MITSUBISHI HEAVY INDUSTRIES, LTD.
16-5, KONAN 2-CHOME, MINATO-KU
TOKYO, JAPAN

Docket No. 52-021
MHI Ref: UAP-HF-08299

Subject: MHI's Partial Responses to the NRC's Requests for Additional Information on Topical Report MUAP-07008-P(0) "Mitsubishi Fuel Design Criteria and Methodology"

Figure 1b-1 Schematic illustration of the behavior of the cladding strain change during AOs as a function of irradiation exposure

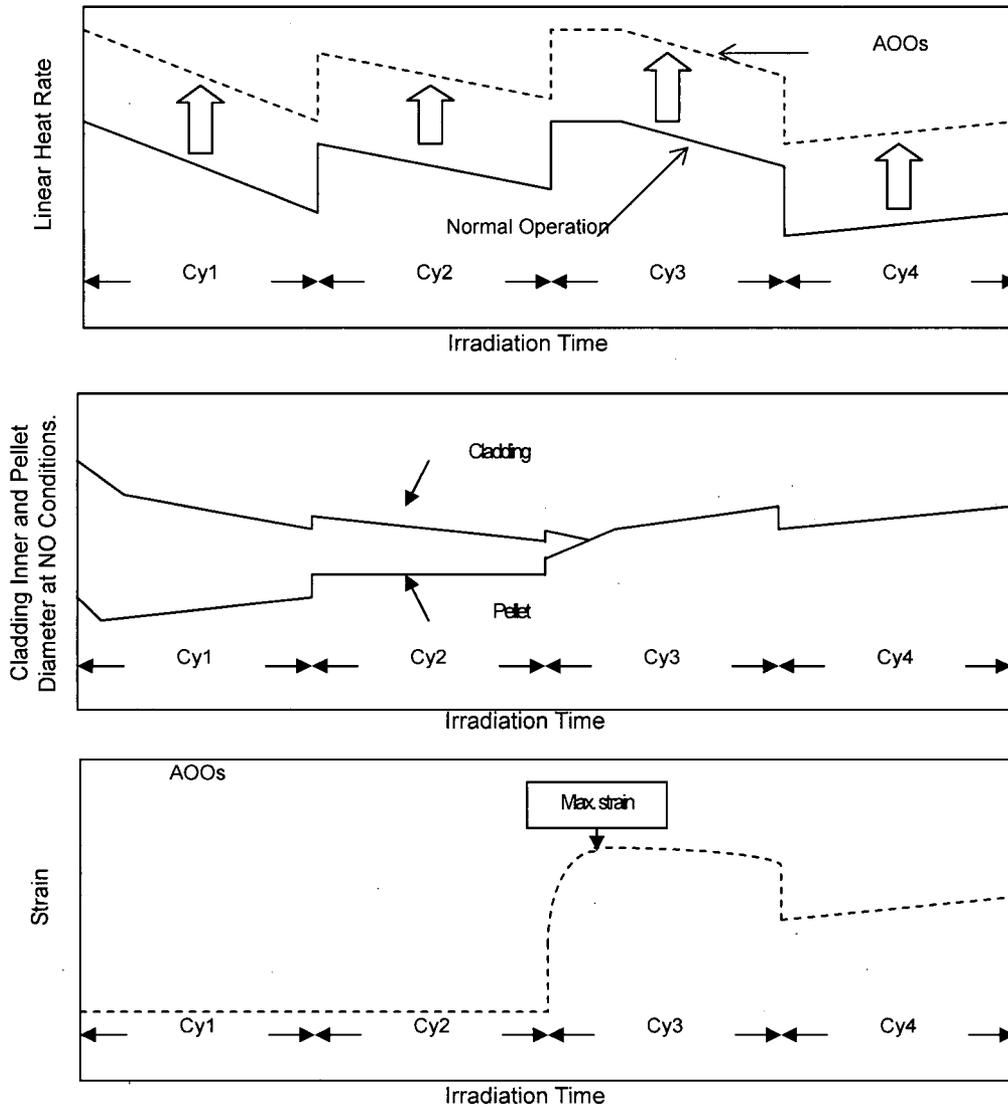
- a. Does this strain criterion include elastic plus plastic strain or just plastic strain?
- b. Provide an example FINE calculation of cladding strain for a limiting anticipated operational occurrence (AOO) event for the advanced pressurized-water reactor (APWR) including the input and output such that an independent calculation can be performed with the U.S. Nuclear Regulatory Commission (NRC) fuel performance FRAPCON-3 code for comparison purposes. Describe how power histories and AOO events are determined for this analysis. How is the burn-up level determined at which maximum cladding strain is calculated?
- c. Provide example calculations of cladding strain both at a 10 GWd/MTU burn-up level below and 10 GWd/MTU above the burn-up level where maximum strain is calculated in b above. This will demonstrate that the burn-up level selected results in calculated maximum cladding strain.

For power transients associated with AOOs, the change in the cladding strain from normal operation to the maximum power of the AOO is evaluated as the total tensile strain change (elastic and inelastic). The strain change during the AOO is principally due to the pellet expansion resulting from the pellet thermal expansion and fission gas bubble swelling. The strain change is therefore independent of the hold time for the AOOs.

The evaluation of the cladding strain change during an AOO considers the irradiation behavior based on the power history for normal operation and the power condition associated with AOOs at every time step during fuel life, as shown schematically in Figure 1b-1. The limiting strain is determined as the maximum strain change during an AOO through the entire fuel rod irradiation history. Typically the maximum strain change occurs at mid-life or later, after the fuel-clad gap has closed at normal operation conditions.

Figure 5a-1 Relationship between mechanical properties and fast neutron fluence

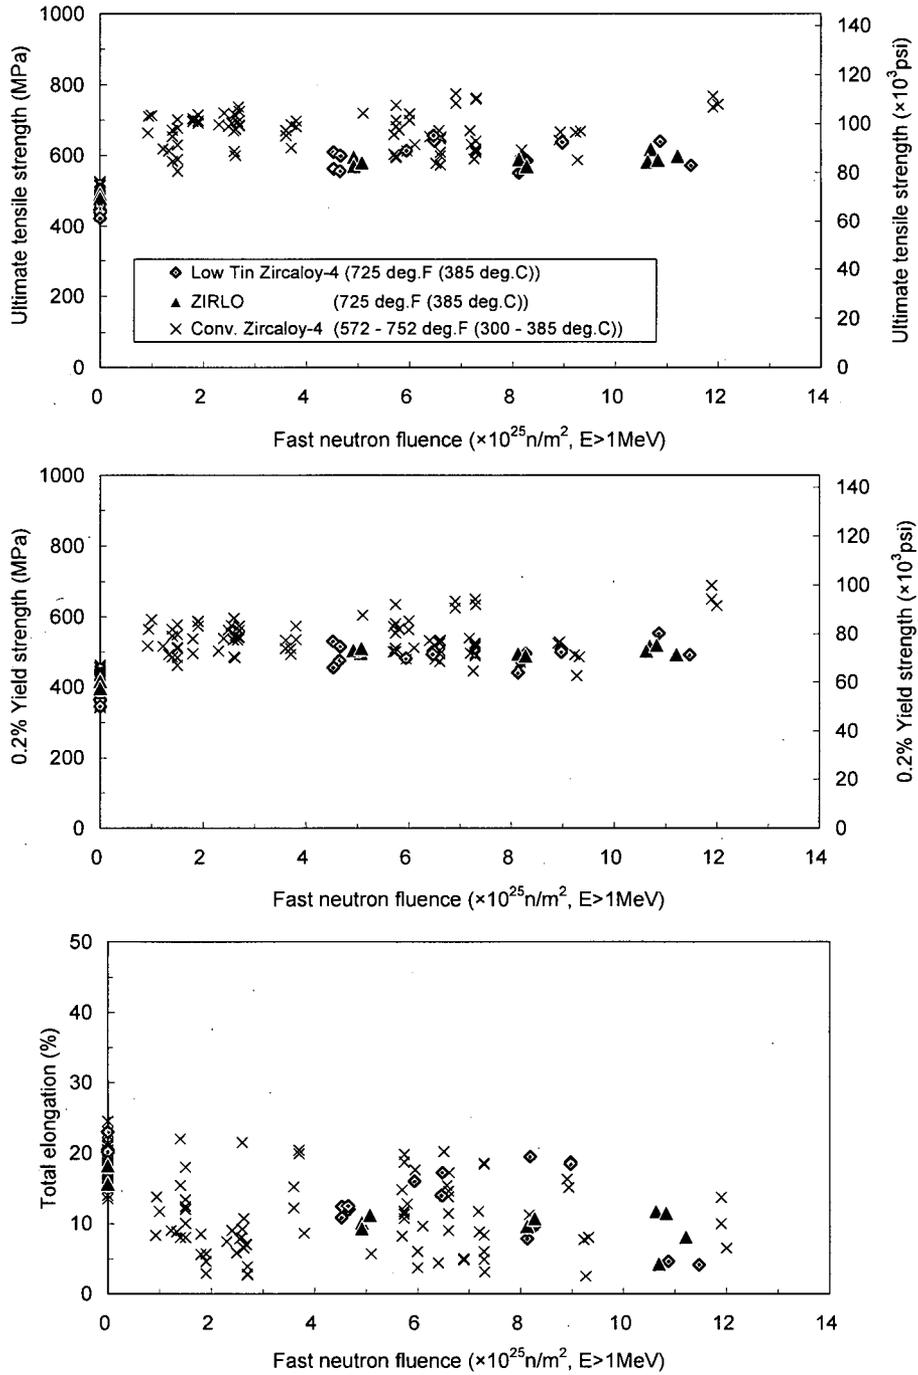
- a. No limit is provided for cladding oxide thickness as Section 4.2 of the current Standard Review Plan suggests to prevent oxide spallation. Provide a proposed limit along with a justification for the limit. Also, the corrosion data supplied in the submittal for verification of the corrosion model only extends to a rod average burn-up of 56.6 GWd/MTU while it is requested that the code be applied up to rod average burn-up of 65 GWd/MTU. Provide additional oxide thickness data up to the requested burn-up level. (See RAI number 38)

Yield strength, UTS and total elongation data for irradiated Zircaloy-4 and ZIRLO are shown in Figure 5a-1. These data show that ZIRLO has essentially the same material properties as Zircaloy-4.

Figure 5a-2 Relationship between cladding hydrogen content and total elongation

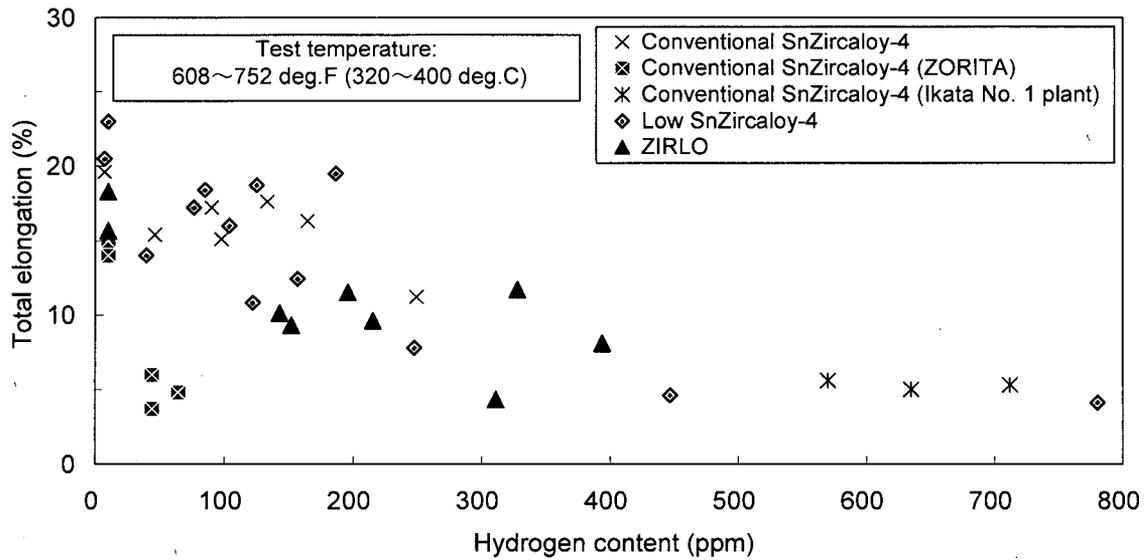
Provide uniform elongation data versus hydrogen level (define how the hydrogen is determined) and versus fast fluence for irradiated cladding to verify that the cladding remains ductile at the proposed hydrogen limit. In the data provided, eliminate those data where hydrogen was artificially charged in the Zircaloy matrix resulting in a uniform hydrogen distribution through the cladding thickness.

Figure 5a-2 shows the results of high-temperature tensile tests of irradiated cladding. These data show that the total elongation decreases as the hydrogen absorption increases up to approximately [] but this effect saturates at higher hydrogen concentrations and the total elongation exceeds the 1 % criterion for hydrogen concentrations up to []. This shows that the 1 % total strain criterion is conservative up to hydrogen concentrations of []
